Subject: Response to U.S. Nuclear Regulatory Commission Request of October 14, 1999, for Additional Information on the Ground Water Compliance Action Plan for the Salt Lake City, Utah, Title I Uranium Mill Tailings Site

# **Salt Lake City, Utah GCAP NRC Request for Additional Information (RAI)**

U.S. DEPARTMENT OF ENERGY GRAND JUNCTION OFFICE, COLORADO	
<b>Monitor Well Locations</b> Salt Lake City, UT			
<small>DATE PREPARED</small> January 17, 2000		<small>FILE NAME</small> U0084000-01

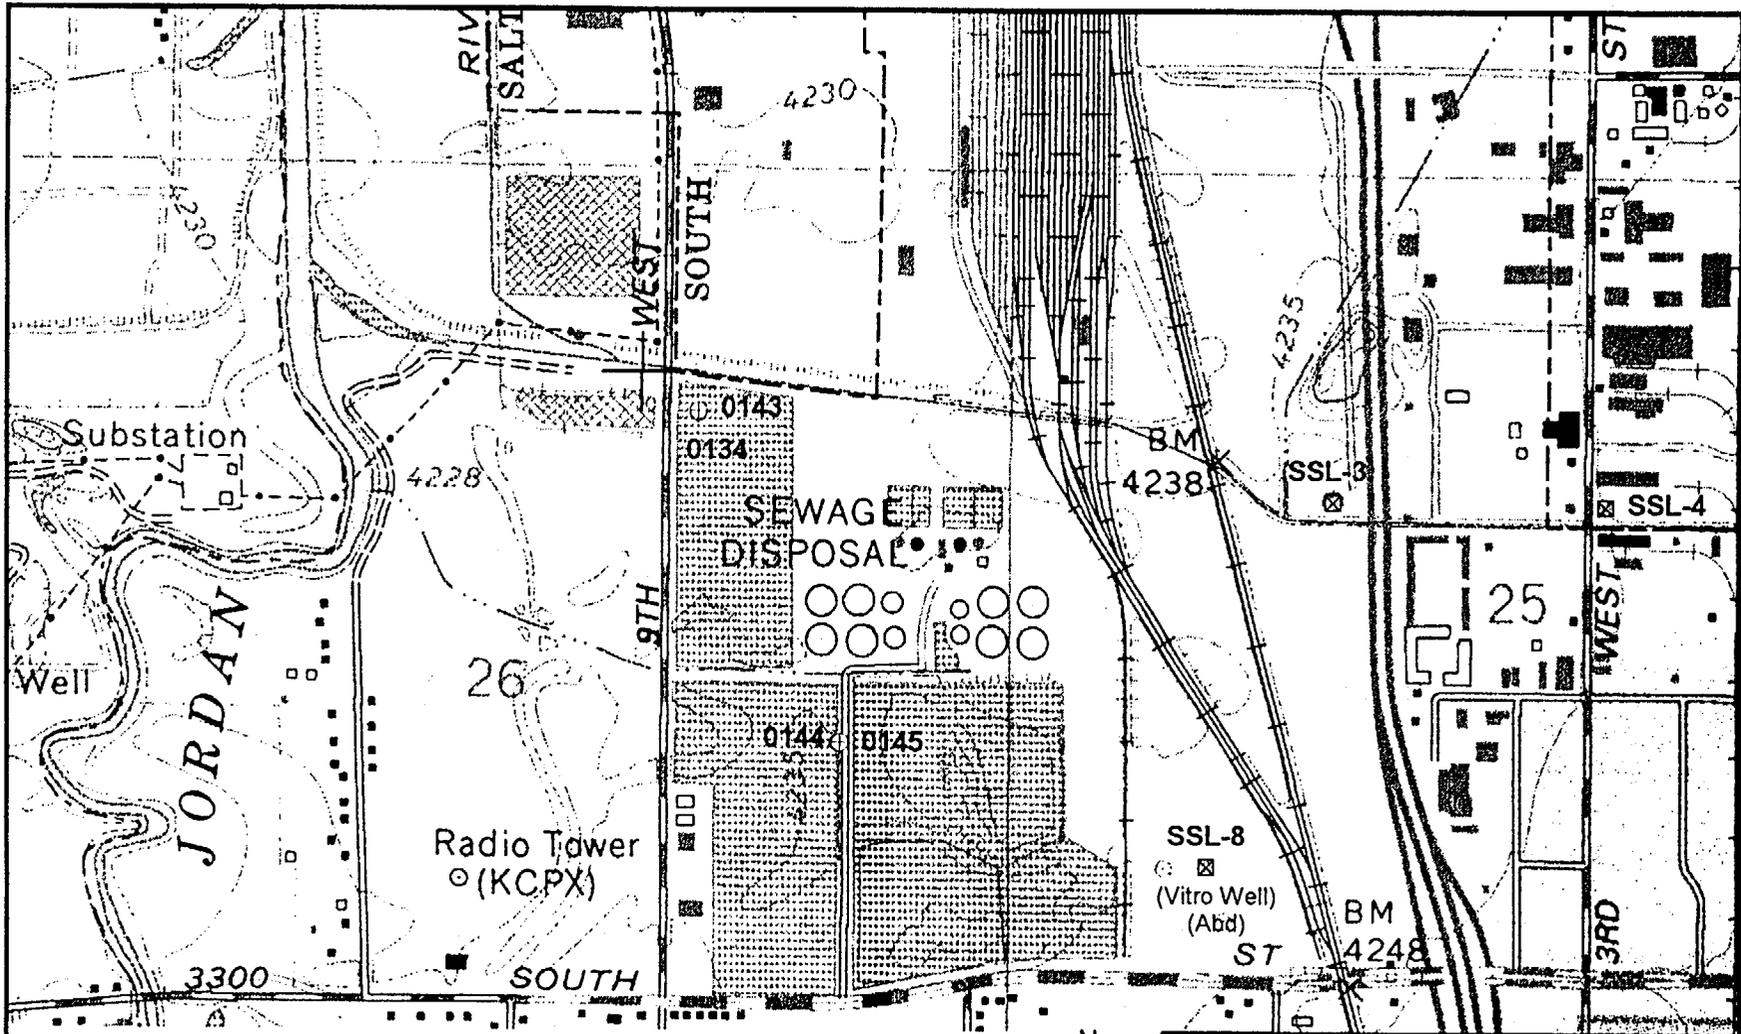
- *Comment 4: Areal photograph of site showing major water supply wells in vicinity.*

The onsite Vitro water supply well (SSL-8) was decommissioned in September 1999. The nearest water supply wells (SSL-3 and SSL-4) are more than one-half mile from the site in a cross-gradient direction (northeast). A modeling study done in 1996 for the City of South Salt Lake (CH2M HILL 1996) showed the delineation (capture) zone for the onsite Vitro well upgradient to the east, and thus not drawing significant ground water from beneath the site. There should be no problem with the potential pumping areas of influence from the more distant wells having any impact in the area beneath the processing site. Locations of nearby water supply wells are shown on the new Figure 2 in the revised GCAP.

Ground water monitoring will be continued at the Salt Lake City site as a best management practice (Table 1 and Figure 2). The primary State concern was possible migration of potentially contaminated ground water in the shallow unconfined aquifer downward into the deeper confined aquifer if the upward vertical hydraulic gradient were to reverse. This will be monitored by measuring ground water levels in pairs of wells completed in the shallow (monitor wells 134 and 144) and deep (monitor wells 143 and 145) aquifers respectively, at two locations onsite and downgradient (Figure 2). DOE will also monitor ground water quality annually in the two wells in the shallow unconfined aquifer (monitor wells 134 downgradient and 144 onsite) to ensure that concentrations of COPCs (molybdenum and uranium) continue to decrease. If there is an indication that the vertical hydraulic gradient is reversed, ground water in the deep confined aquifer will be sampled and analyzed to ascertain that no site-related constituents migrate into the deeper aquifer. Baseline monitoring in October 1999 shows that there is a strong upward vertical hydraulic gradient and that concentrations of uranium and molybdenum in ground water in the deeper confined aquifer are near or below the detection limit (Attachments G and H).

As an added precaution against potential contamination of ground water in the deeper aquifer the Vitro water supply well in the southeast corner of the site was decommissioned in September 1999 (Figure 2 and Attachment H). The well has been in place for a number of years and the integrity of the annular seal was unknown. The well belonged to the City of South Salt Lake who was not using the well and had no plans to do so. The City of South Salt Lake granted DOE authorization to decommission the well.
